Issue	**1**
Factory ID	**25298**
Date of Issue	**11-Jun-2026**

Smart Apparel (Pvt.) Ltd.

Structural Safety Inspection Report

Pakistan Accord Initial Safety Inspection Report

Figure 2.3 - Corrosion of Column Dowel Reinforcement at First Floor Level of Building 2

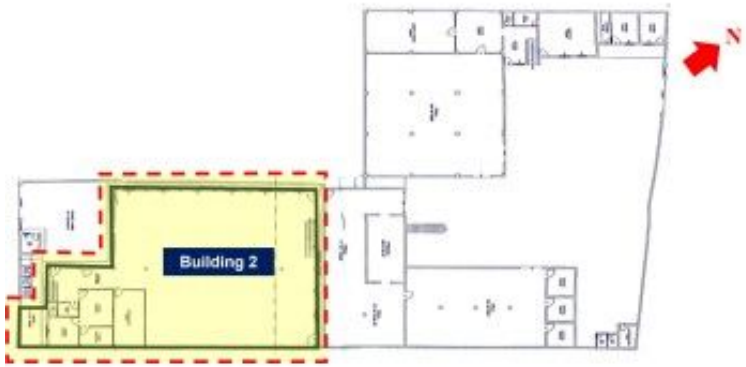
The dowel reinforcement of the columns at the first floor level of Building 2 has been significantly affected by atmospheric corrosion. This condition may compromise the structural integrity over time.F-202604-065693

Timeline	Remediation Plan
Medium Term CAP-0078071	Propose the remedial measure to protect the dowel reinforcement from future atmospheric corrosion and submit to Pakistan Accord for review.
Longer Term CAP-0078072	Implement the required remedial work.
